PROPOSED DRAFT GLOBAL TECHNICAL REGULATION (GTR)
on
PEDESTRIAN PROTECTION.

This document is a working document circulated for discussion and comments. It is only submitted with the intention to facilitate discussion by the GRSP Informal Group.

Wording added in blue are comments from OICA

Wording added in red are comments from EU

Figure 13: Windscreen test area.

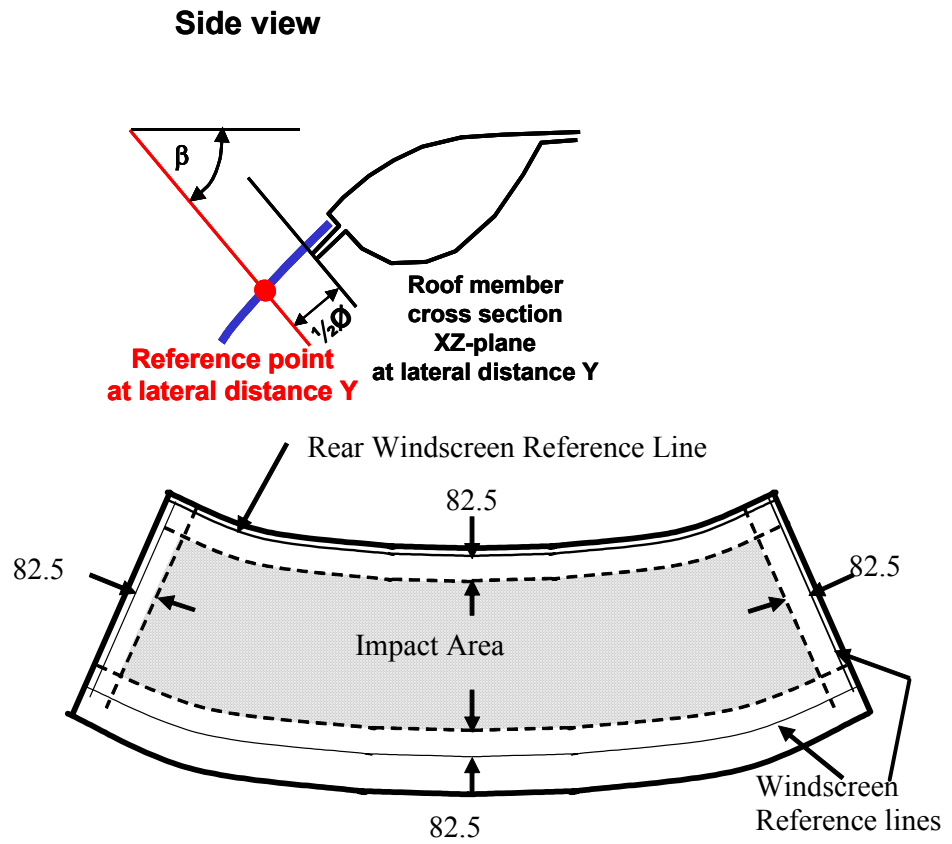
EU Comment: This diagram requires more discussion and agreement.

[EU Comment: This diagram requires more discussion and agreement.](#)

[EU Comment: This diagram requires more discussion and agreement.](#)

Figure 14: Lower legform impactor.

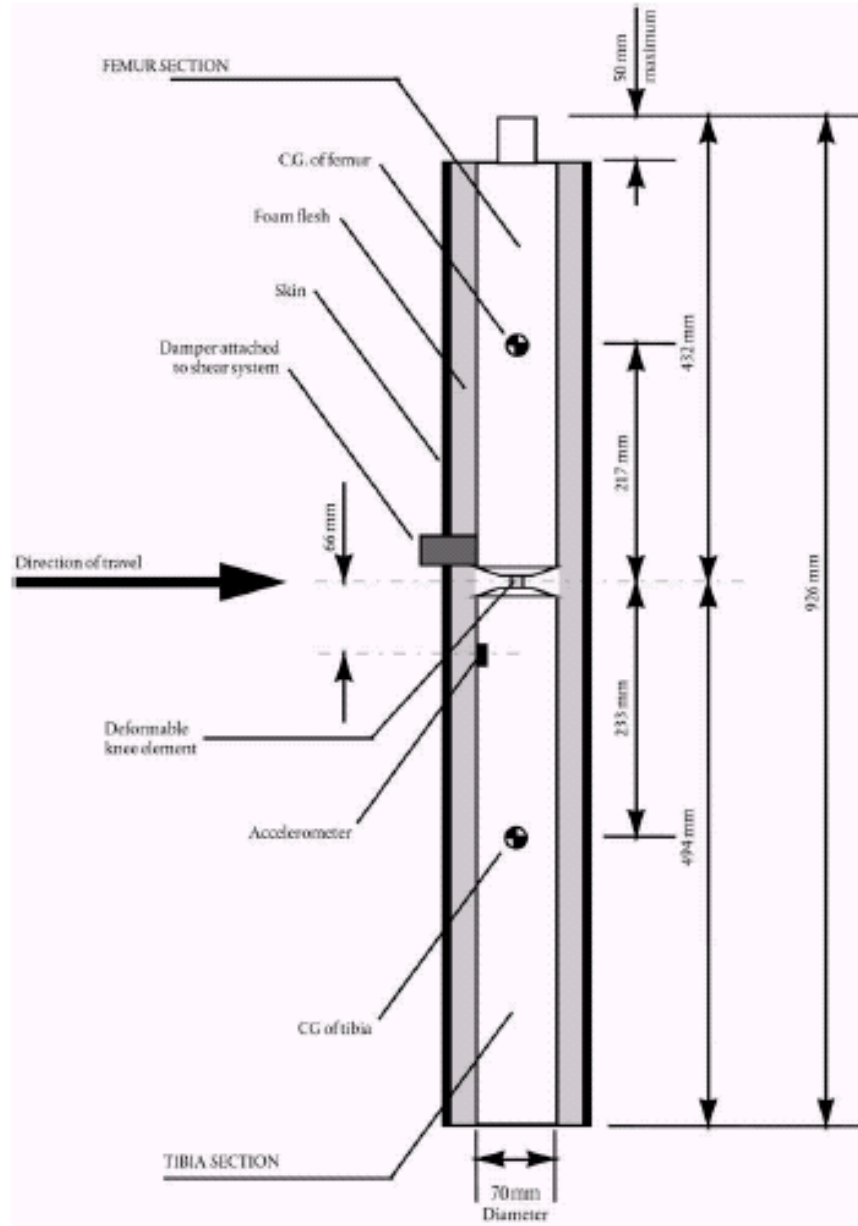
OICA comment: It appears that chapter 6.3.1.1.9 is more related to the test procedure in 7.1.1.

Figure 18: Tolerances of angles for the lower legform impactor at the time of first impact

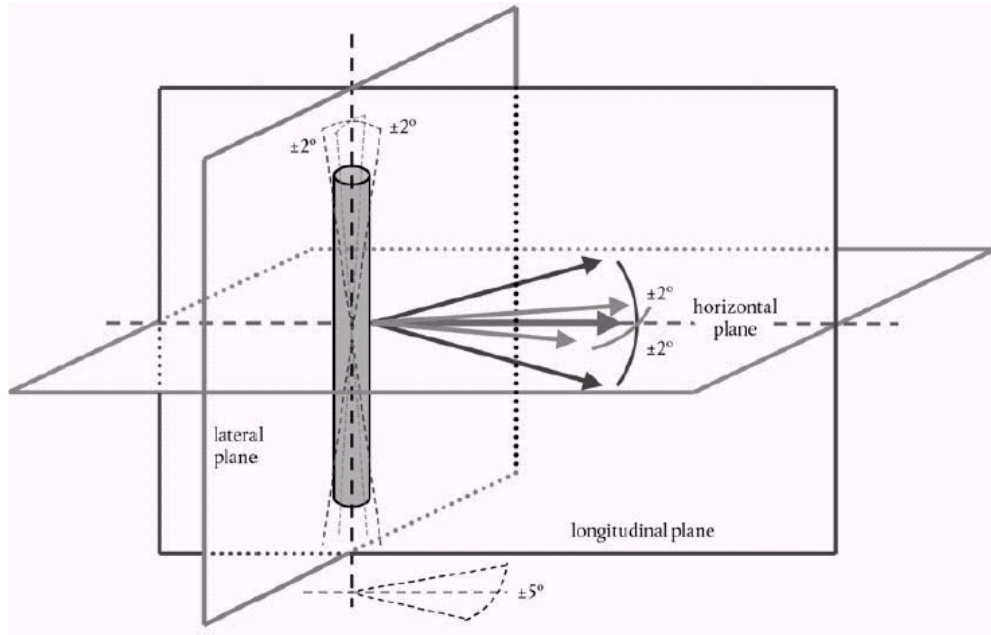
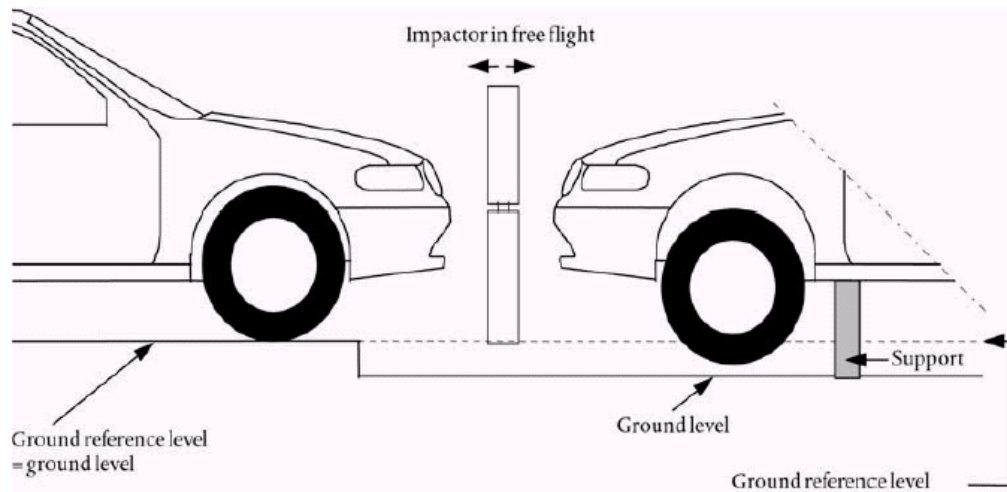
OICA comment: Smaller tolerances in the above definitions of the legform impactor position at time of first contact should be checked. The sum of all tolerances might result in considerable differences of the measurement.
